1435 - P095

Bedroom//Existing///Plan_1:20

Rev	Date	Notes
A	23.06.15	Radiator added and joinery removed .

Bedroom//Existing//Elevation 1_1:20

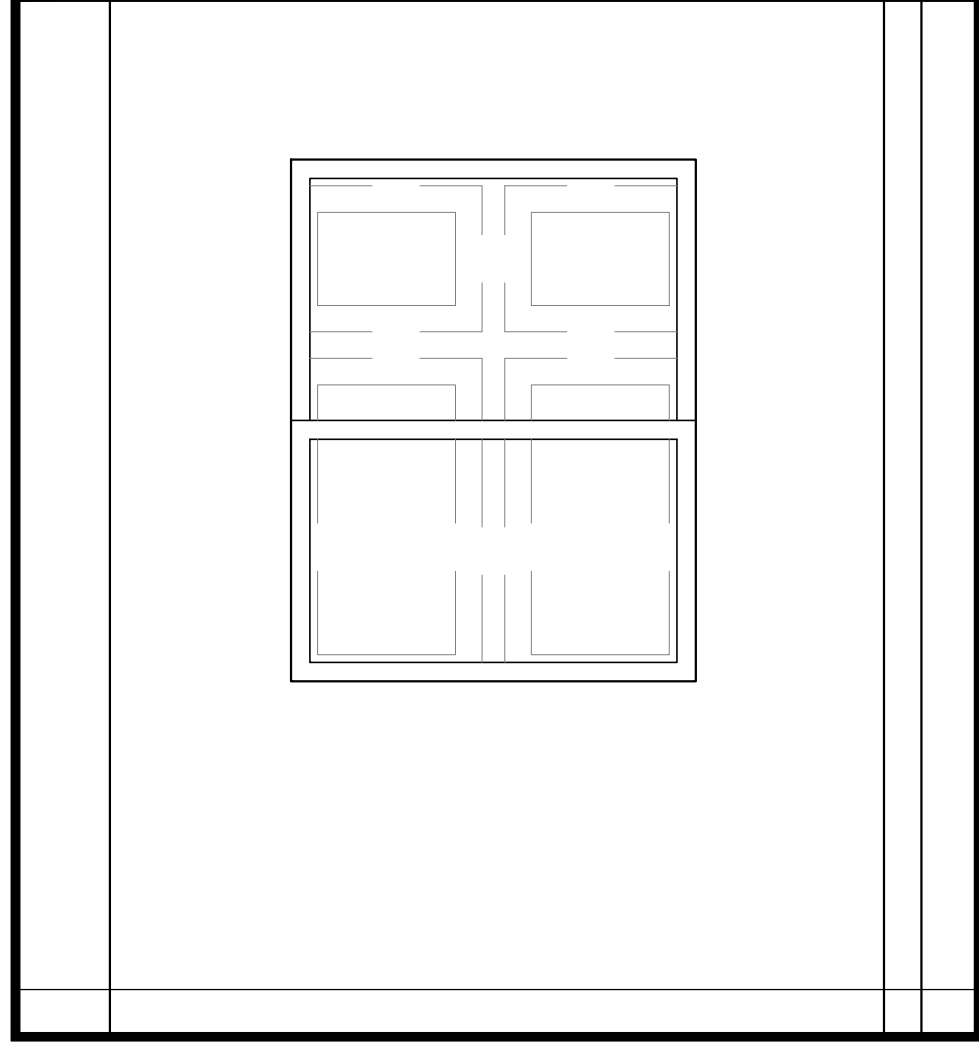
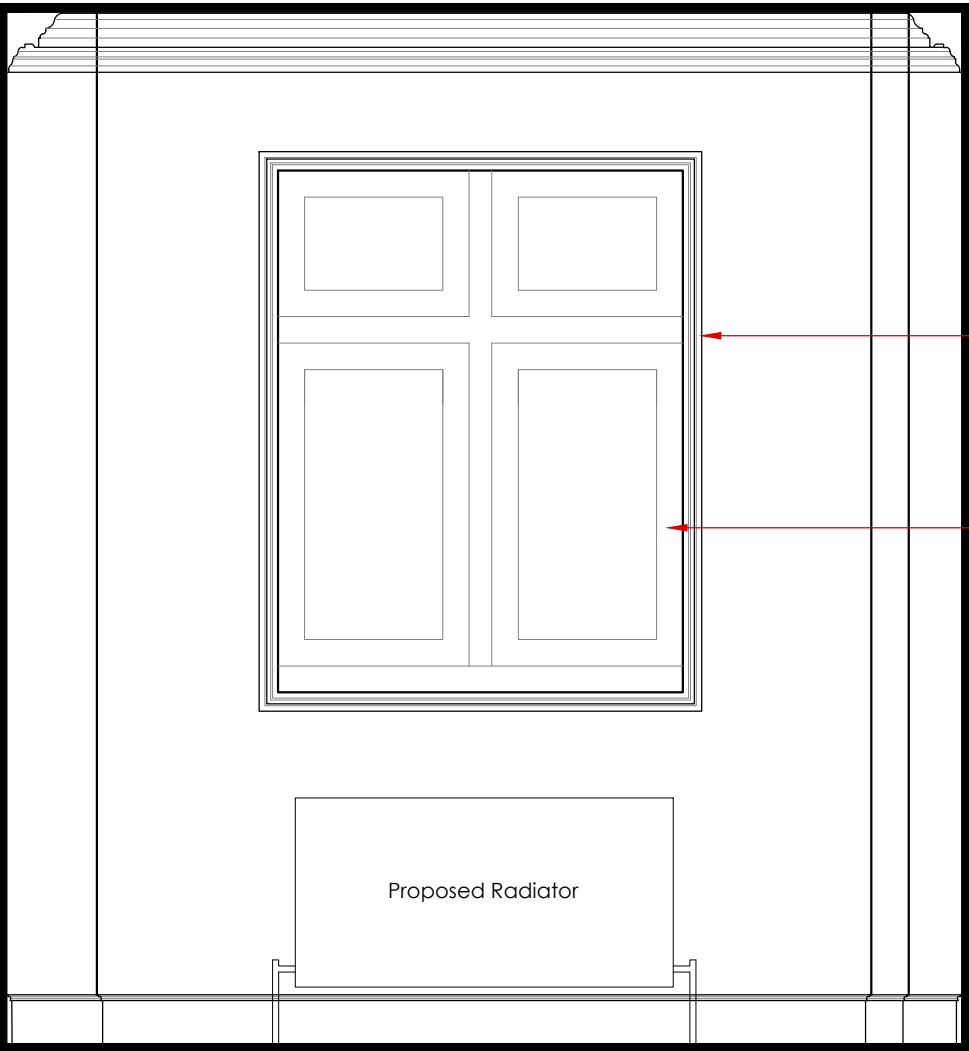
Proposed 50mm
architrave to window.

Existing secondary
glazing removed and
window overhauled.

Proposed Radiator

Rev	Date	Notes
A	23.06.15	Radiator added and joinery removed.

Bedroom//Existing//Elevation 2_1:20

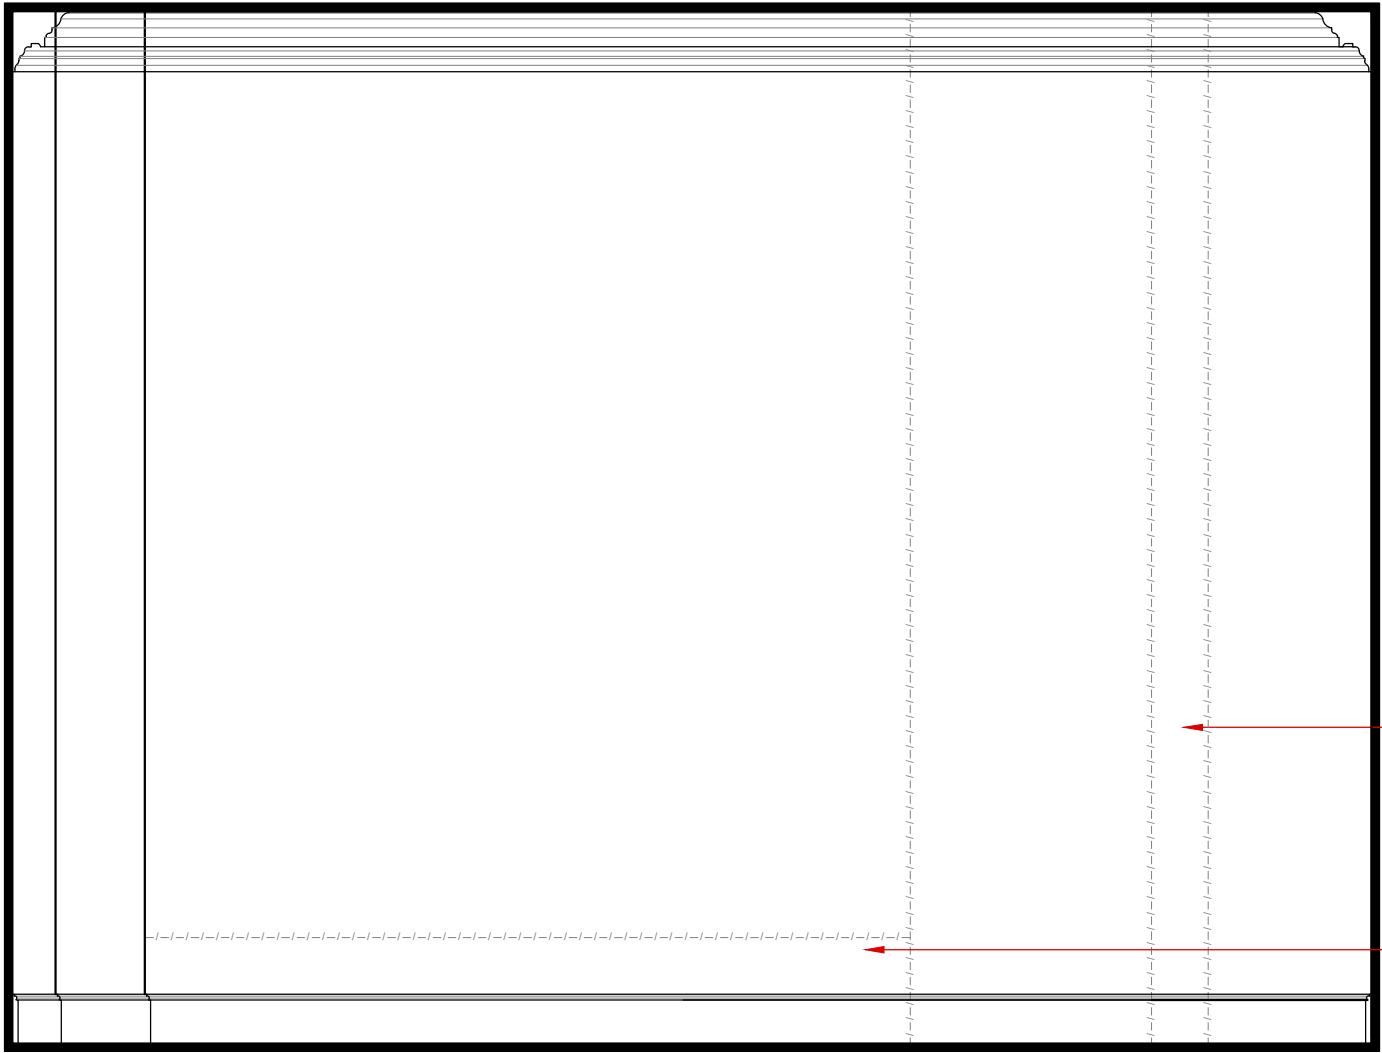
Existing wall between
bedroom and dressing
room removed.

Existing low level boxing
and pipework removed.

Rev	Date	Notes
A	23.06.15	Joinery removed.

Bedroom//Existing//Elevation 3_1:20

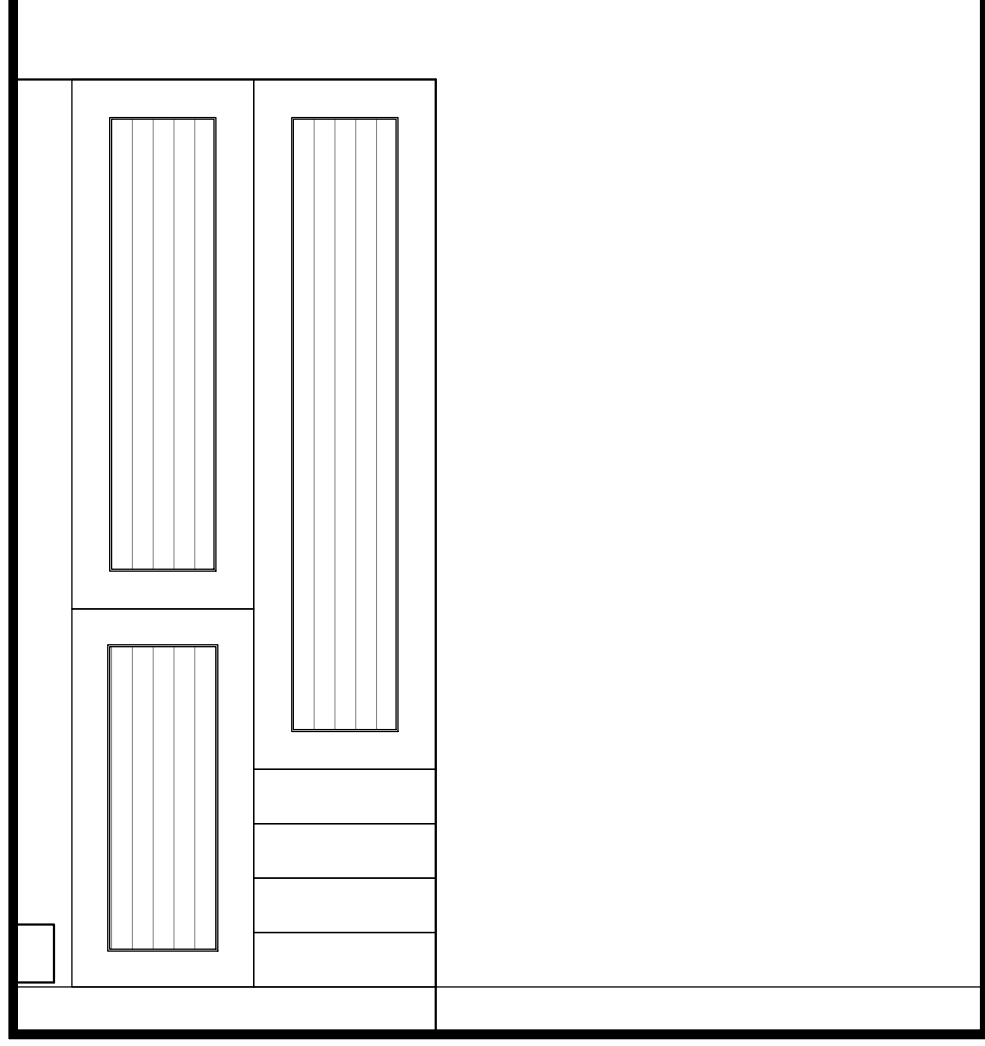
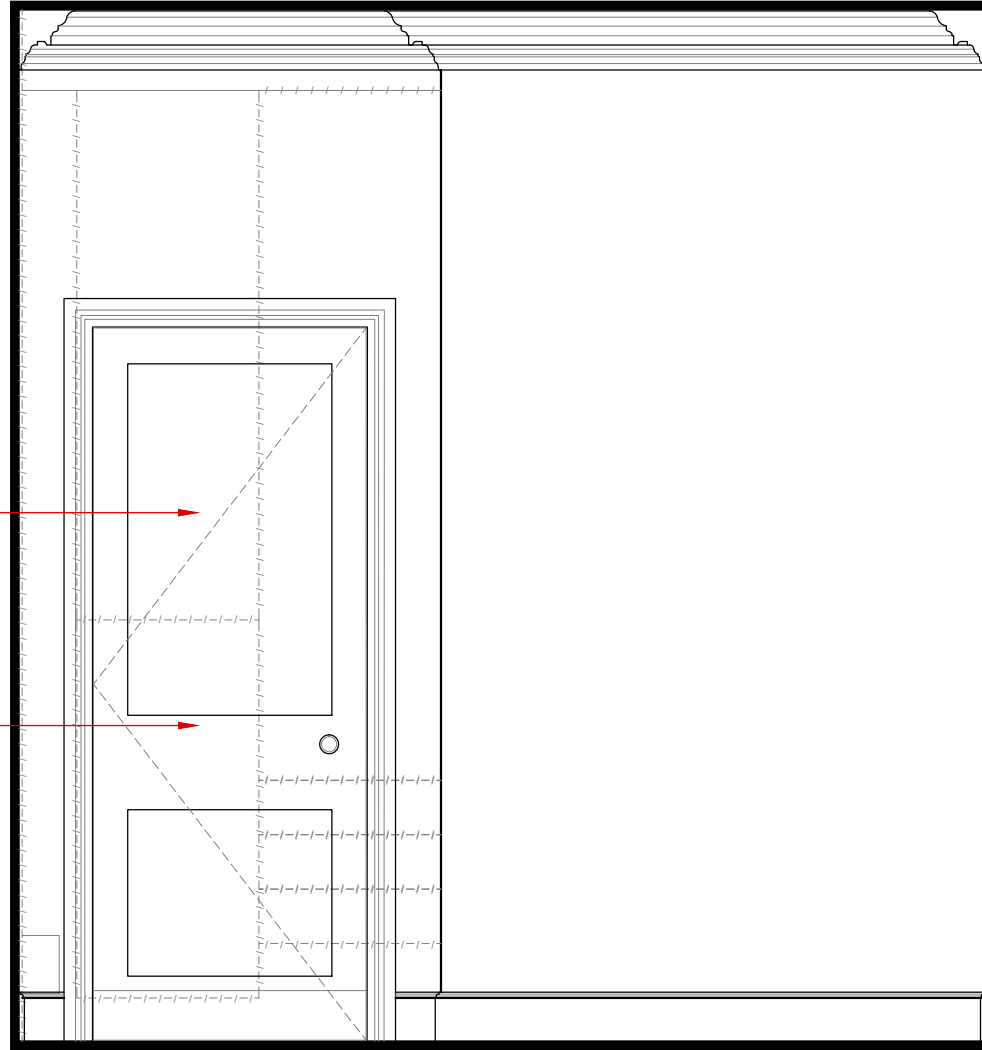
Existing joinery removed
and doorway proposed
through to bedroom.

Proposed door and
architrave to match
D.1.06.

Rev	Date	Notes
A	23.06.15	Joinery removed.

Bedroom//Existing//Elevation 4_1:20

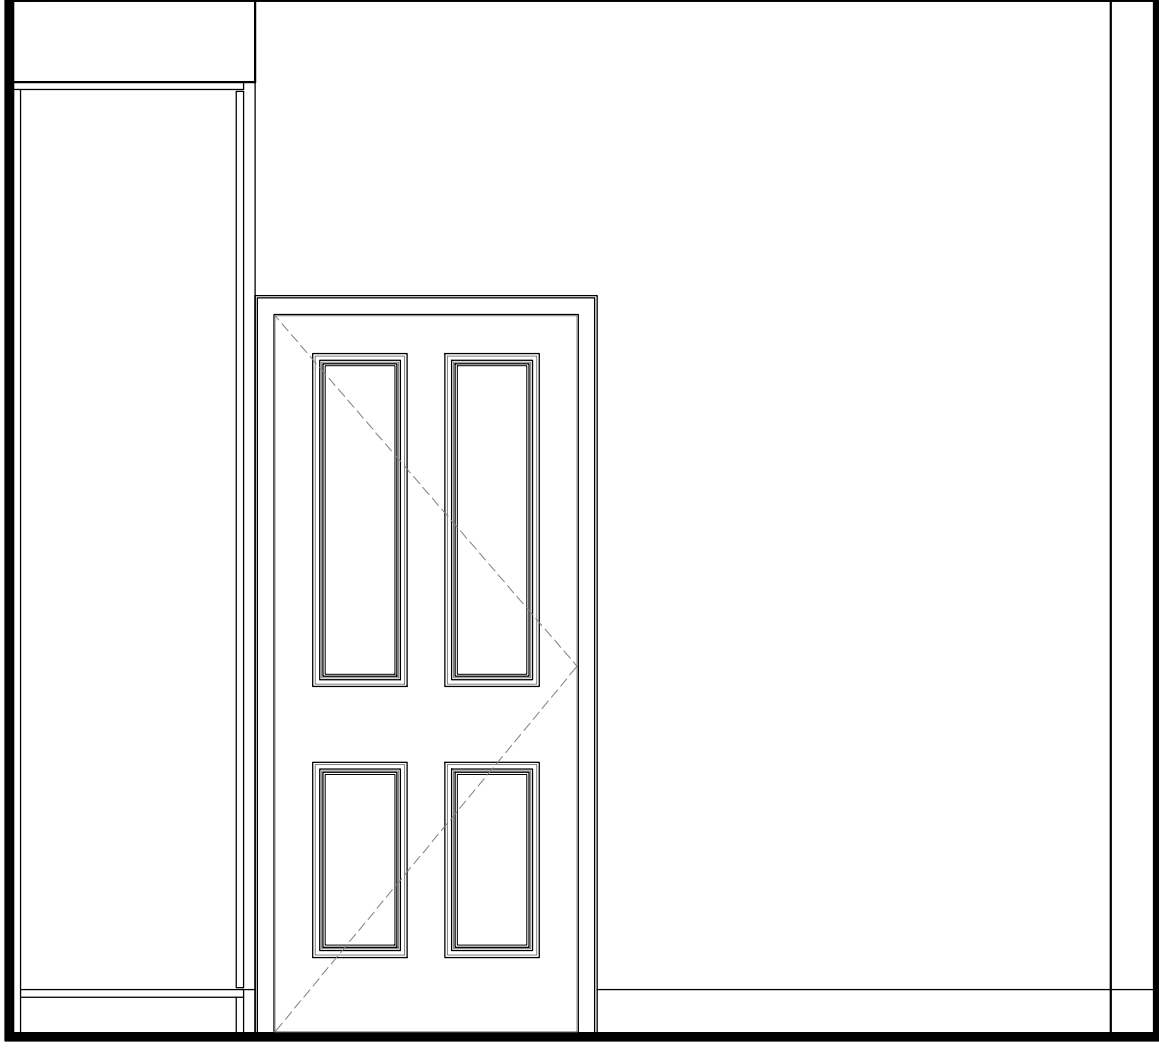
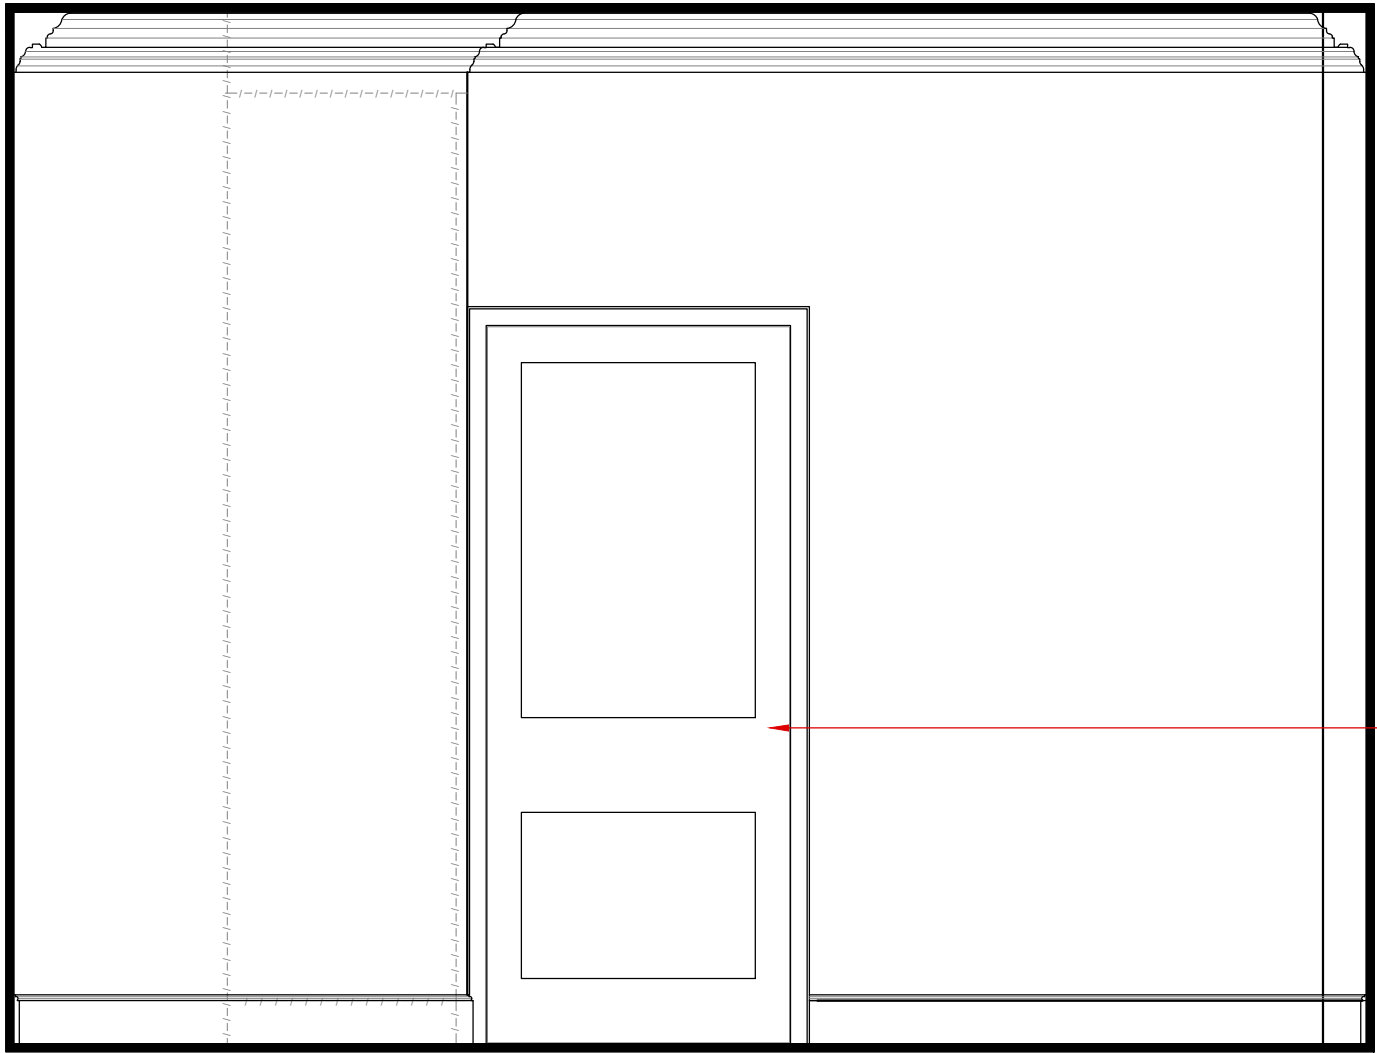
Proposed door to match
D.1.06 to be fixed
closed. Existing
non-original architrave
to be replaced D.1.06.

Rev	Date	Notes
A	23.06.15	Joinery removed.
